File 1992-0029

Name: Habitat Subdivision - Replat Lots 1 & 3 - Kelley7 Sub. Cheyenne and Mtn View

Subdivision Name: HABITAT SUBDIVISION Filing 1

HABITAT SUBDIVISION IRRIGATION PLAN

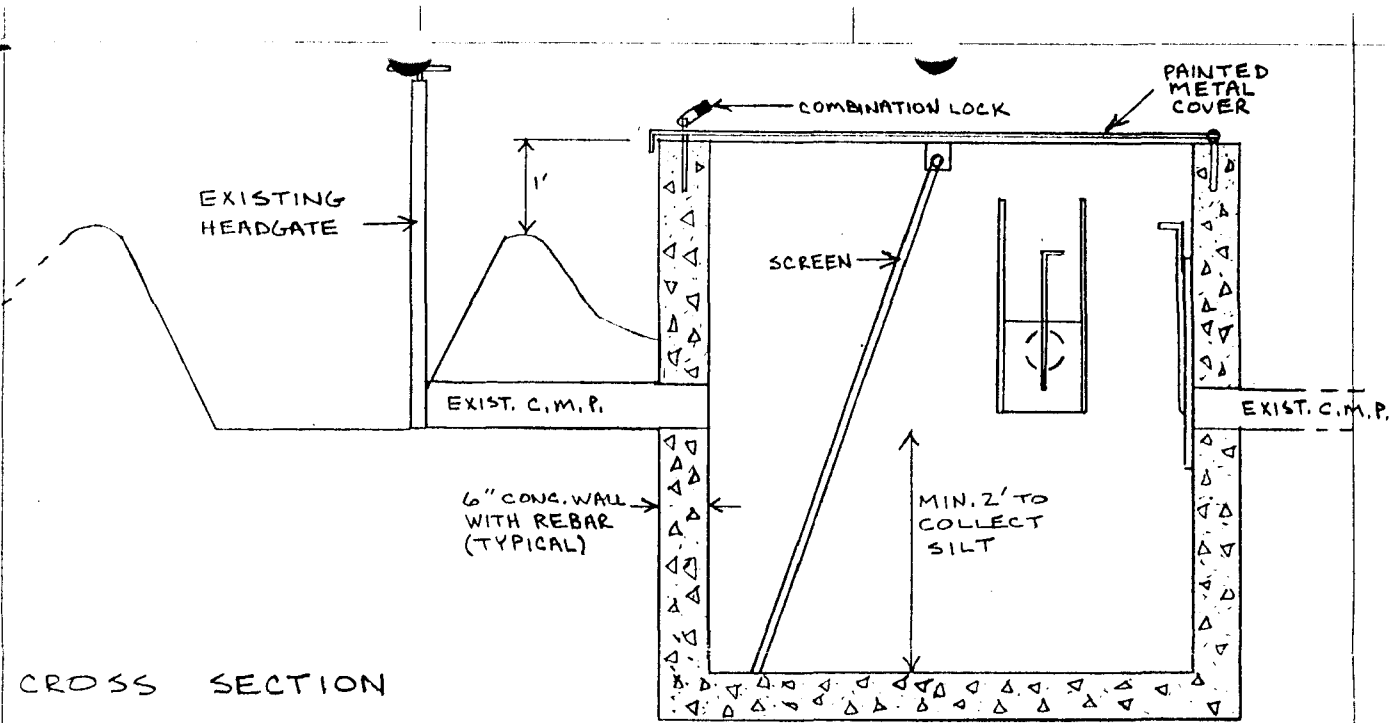
Each lot of the proposed subdivision has Orchard Mesa Irrigation water permanently assigned to the land. Water is delivered at the headgate serving the original undivided property. It is the subdivider's responsibility to provide a properly engineered system to deliver the irrigation water to each lot.

The proposed subdivision documents do not include any plans for delivery of the water. We recommend that the proposed subdivision be denied until a properly engineered irrigation delivery plan is included.

This letter is in response to your review comments on the Resubdivision Application submitted by our group.

In accordance with our telephone conversation, we have developed an irrigation system plan which is attached. We plan to install this system next winter when the water is out of the ditch where we will tie in.

Although the maintenance on this system will be minimal, we plan to set up a cooperative for the future users that will collect a small annual fee to cover the anticipated operating and maintenance costs for the system.

The attached letter dated July 10, 1992 from "Habitat of Mesa County" with attachment should provide an adequate irrigation system for the proposed development. On the condition that the work is completed as proposed, our District recommends your approval of the project.
